REF. : H-P-ASP-MN-4776	
				SPIRE Progress & Interface	
				DATE : 28/04/04	PAGE : 1/21
<b>COMPTE RENDU DE REUNION / MINUTES OF MEETING</b>				LIEU / PLACE : Telecon	
OBJET / PURPOSE :				CLASSIFICATION :	
<b>SPIRE Progress &amp; Interface Telecon</b>					
PARTICIPANTS ATTENDEES	SOCIETE FIRM	SIGNATURE SIGNATURE	PARTICIPANTS ATTENDEES	SOCIETE FIRM	SIGNATURE SIGNATURE
Guy Doubrovik	ASP		John Delderfield	RAL	
Bernard Collaudin	ASP		Eric Sawyer	RAL	
Carsten Scharmberg	ESA		Eric Clarck	RAL	
Horst Faas	ASED				
Marco Cesa	ALS				
REDACTEUR / WRITTEN BY :					
Guy Doubrovik					
CONCLUSION :					
DISTRIBUTION : PARTICIPANTS / ATTENDEES	POUR ACTION : FOR FURTHER ACTION				
	POUR INFORMATION : FOR INFORMATION				
APPROUVE PAR / APPROVED BY					
NOM / NAME					
SIGNATURE / SIGNATURE

**Agenda : see Annex 1**

**Annex 2 – 4/4**  
**COMMENTS ON SPIRE IID-B\_3-2\_RAL\_JD**  
**With Guy Doubrovik answers (18/0304, reviewed 20/04/04)**

SCI-PT-IIDB/Spire-02124 issue 3.2 sign off notes.

**P 2-1**

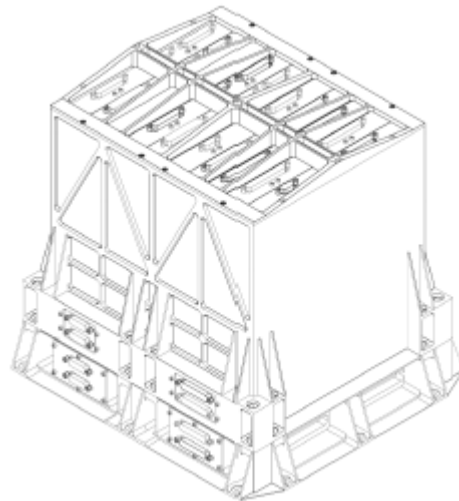
Twice, one word “hereafter”, not “here after”. **Done on 3.2 final.**

**P 5-14, §5.6.1.2**

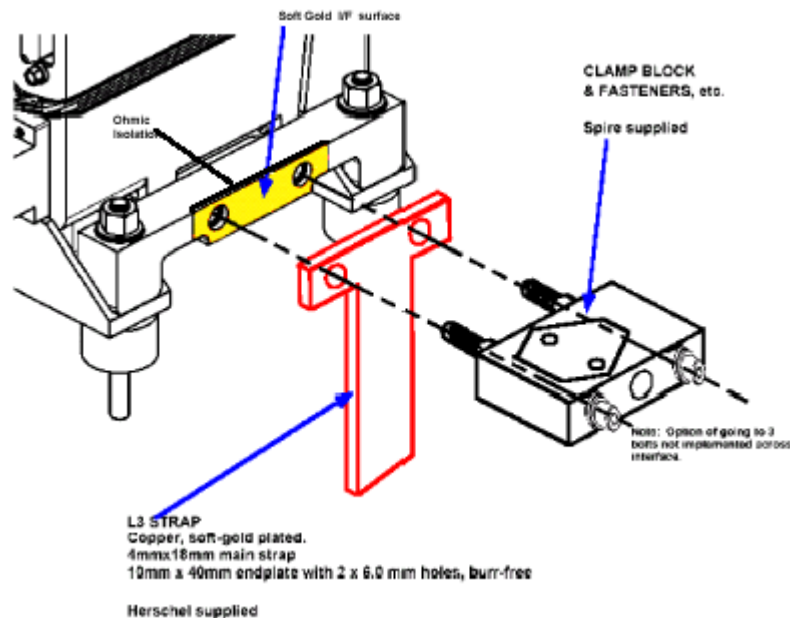
Change words “Kapton Tape” in 7<sup>th</sup> paragraph to “Ohmic isolation”, and drop in this updated diagram: **To be fixed in next issue for Syst CDR, if agreed by ASED.**
